**HORIZONTAL DIRECTIONAL DRILL ANALYSIS
CAMPBELL CREEK/GEORGE CREEK CROSSING
PADEP SECTION 105 PERMIT NO. E31-234
PA-HU-0110.0000-SR-16
(SPLP HDD# S2-0155-16)**

This reevaluation of the horizontal directional drill (HDD) installation of a 16-inch diameter pipeline that traverses under George Creek, and wetland K-68 in Tell Township, Huntingdon County, has been completed in accordance with Condition No. 3 of the Stipulated Order issued under Environmental Hearing Board Docket No. 2017-009-L. Condition No. 3 stipulates, for HDDs initiated after the temporary injunction issued by the Pennsylvania Department of Environmental Protection (PADEP) Environmental Hearing Board on July 25, 2017, a reanalysis must be performed on HDDs for which an inadvertent return (IR) occurs during the installation of one pipe (20-inch or 16-inch diameter) where a second pipe will thereafter be installed in the same right-of-way (ROW).

RE: Sunoco Pipeline, L.P. Pipeline Project - Mariner East II
George Creek HDD S2-0155, PA-HU-0110.0000-SR
Hydrogeologic Re-Evaluation Report for 16-Inch Pipeline
Tell Township, Huntingdon County, Pennsylvania
RETTEW Project No. 096302011

Figure 1. Original Permitted 16-Inch HDD Plan and Profile

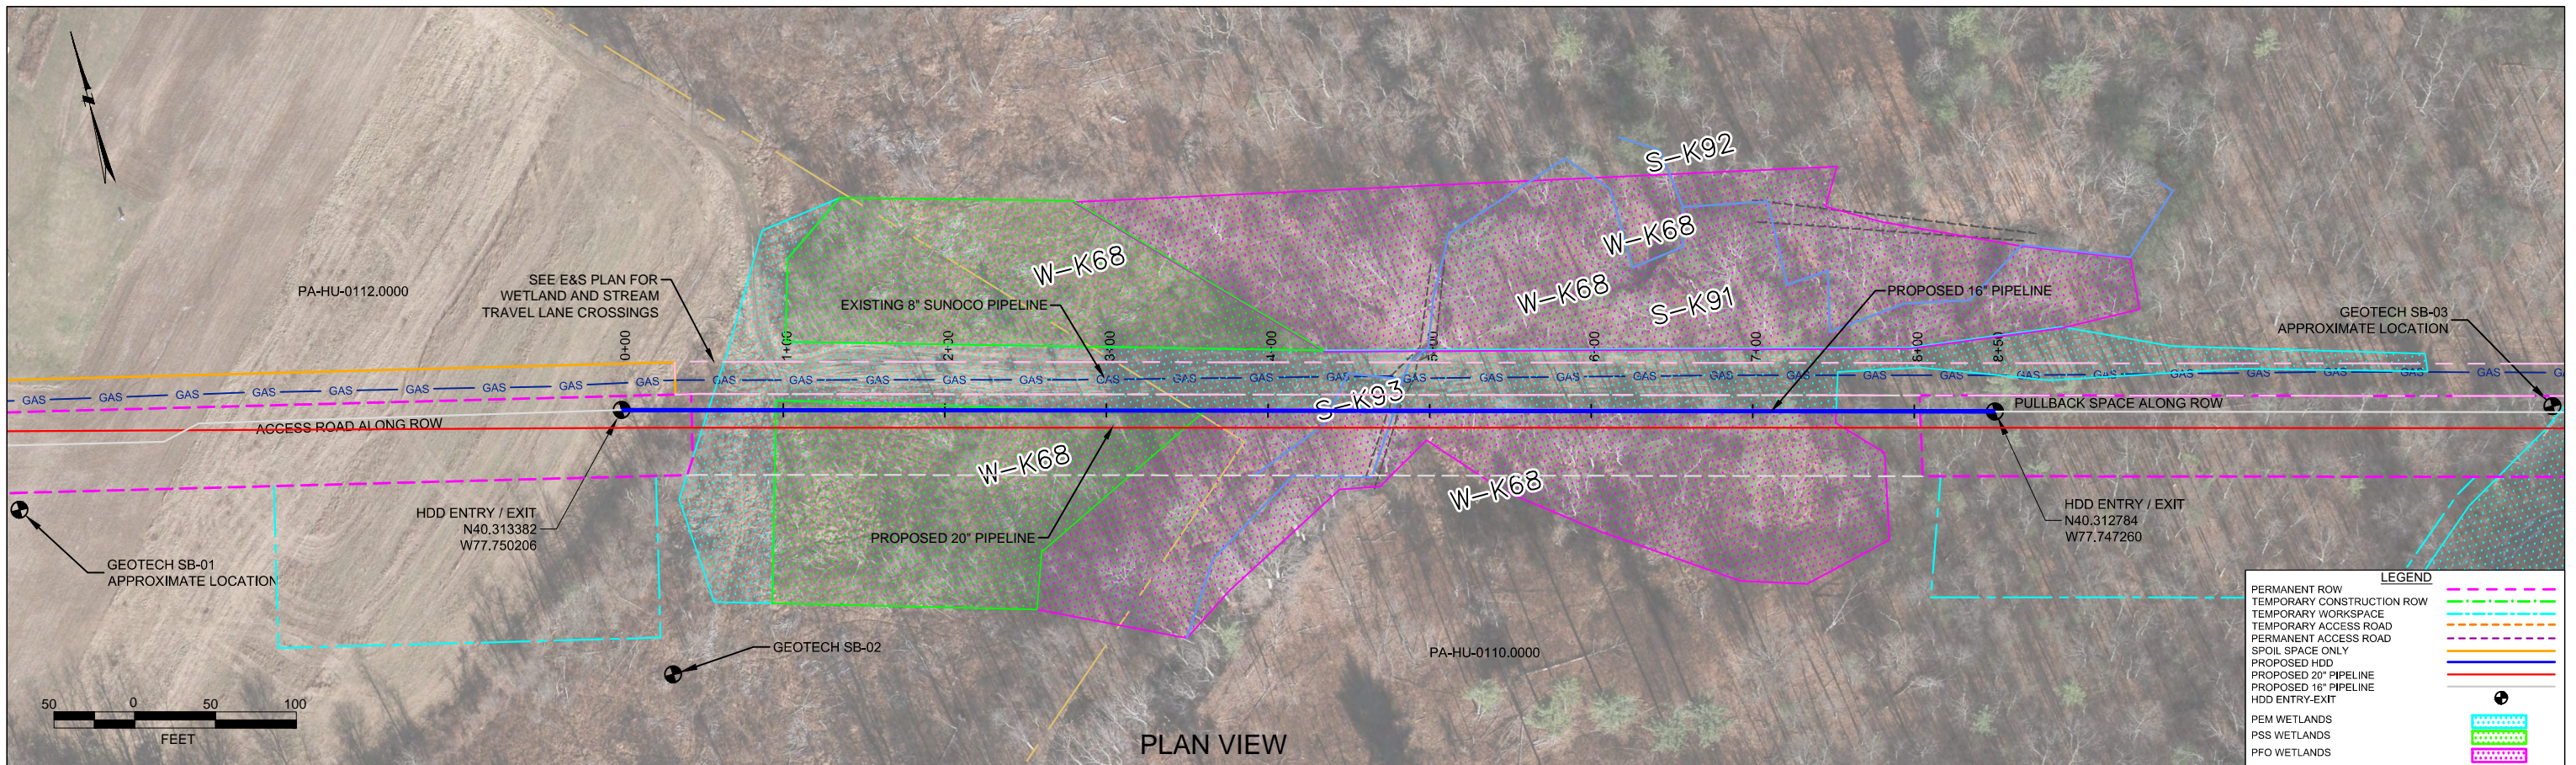
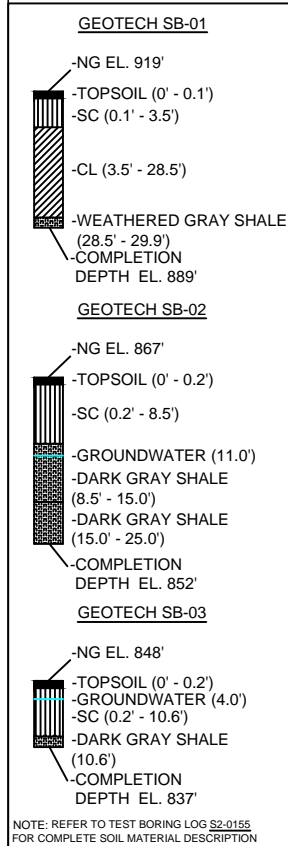
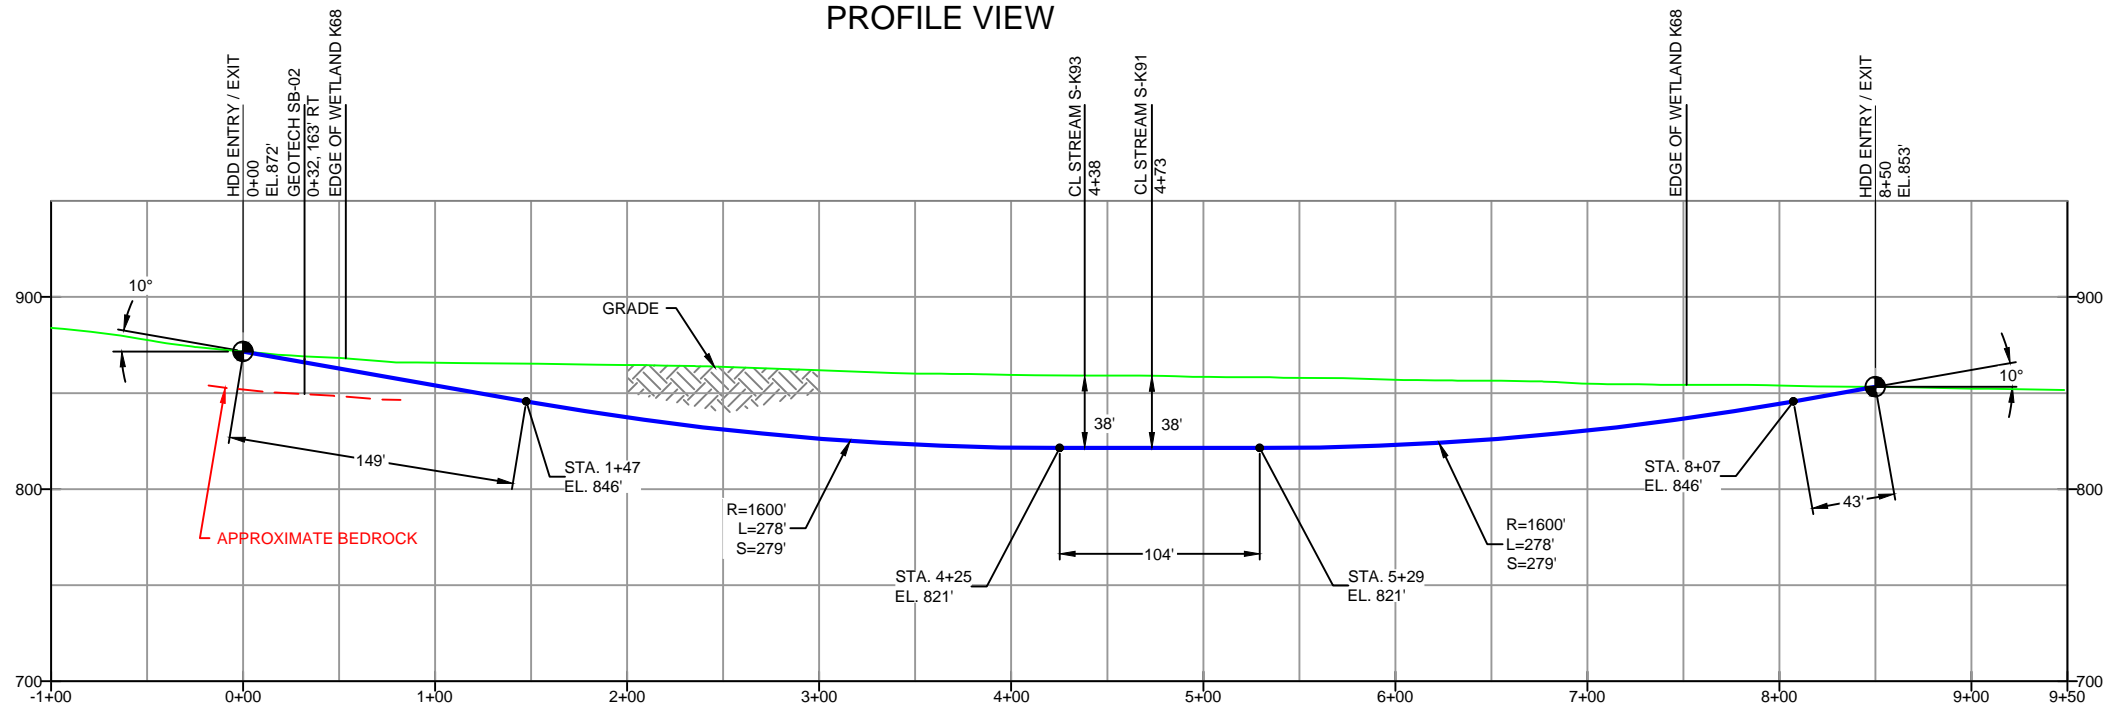
ORIGINAL HORIZONTAL DIRECTIONAL DRILL DESIGN SUMMARY: 16-INCH

- Horizontal length: 850 foot (ft)
- Entry/Exit angle: 10 degrees
- Maximum Depth of cover: 38 ft
- Depth below wetland K-68: 3-15 ft
- Depth below George Creek: 38 ft
- Pipe design radius: 1,600 feet

Figure 2. Revised 16-Inch HDD Plan and Profile

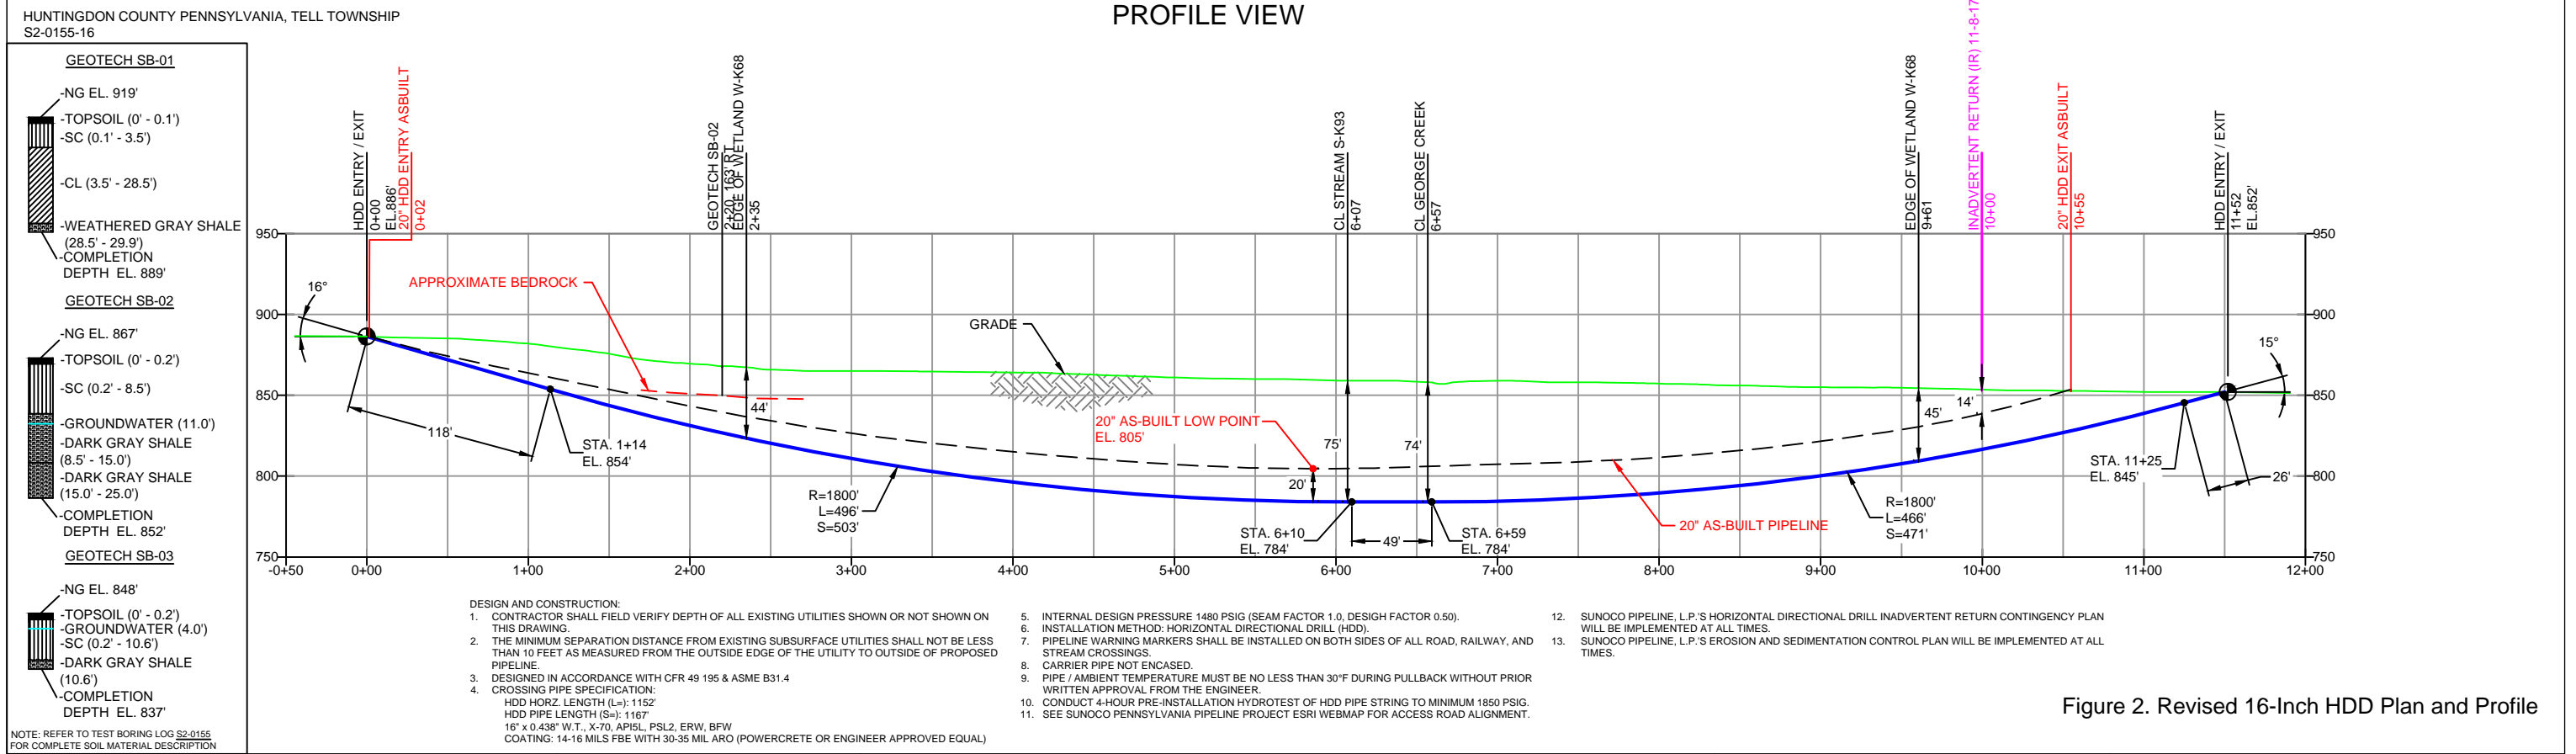
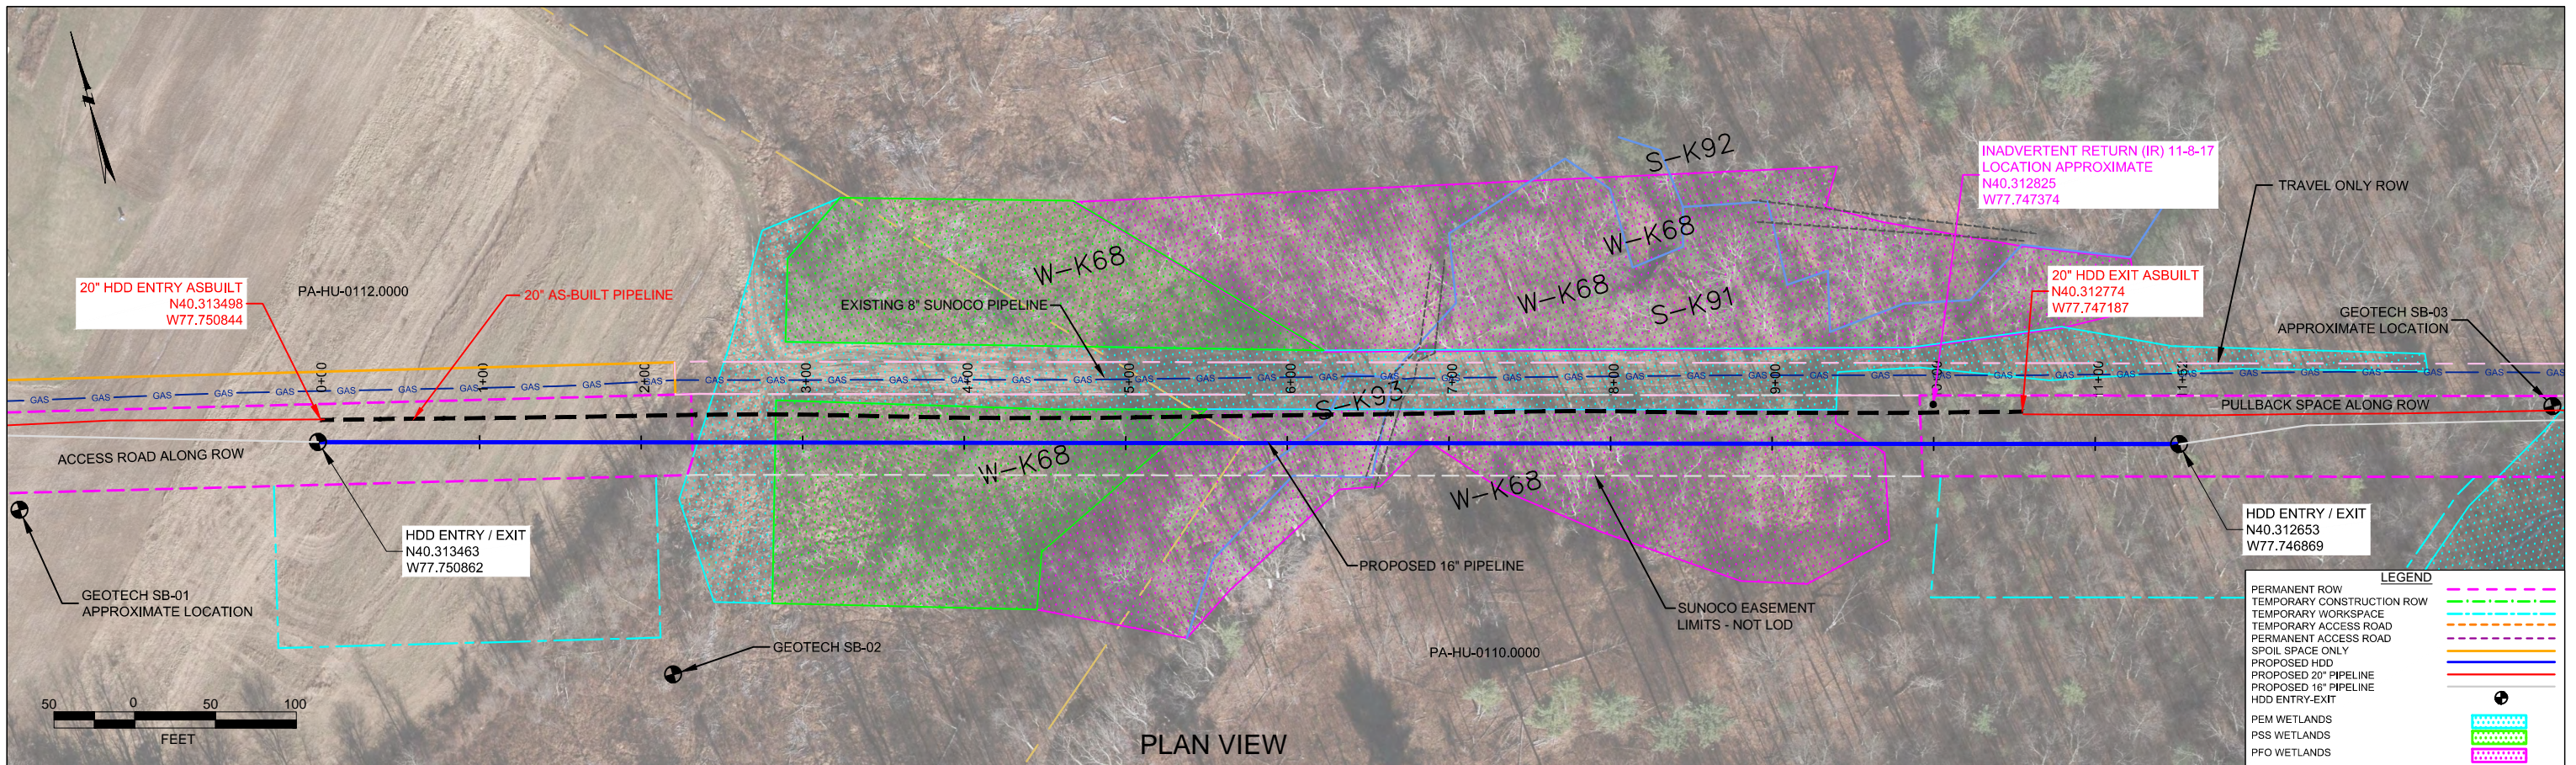
REDESIGNED HORIZONTAL DIRECTIONAL DRILL DESIGN SUMMARY: 16-INCH

Based on a comparison of the original and revised profiles for HDD S2-0155-16, the revised profile will be increased by 302 feet and the depth of profile will be increased by 37 feet to be sure the pipe is installed in bedrock below the aquatic resources. The entry/exit angles were increased by 5 to 6 degrees allowing the drill to more quickly enter bedrock, therefore minimizing the amount of time the HDD is within the unconsolidated overburden. The revised HDD profile greatly reduces the risk of creating IRs.

- Horizontal length: 1,152 foot (ft)
- Entry/Exit angle: 16 degrees
- Maximum Depth of cover: 75 ft
- Depth below wetland K-68: 44-75 ft
- Depth below George Creek: 74 ft
- Pipe design radius: 1,800 feet
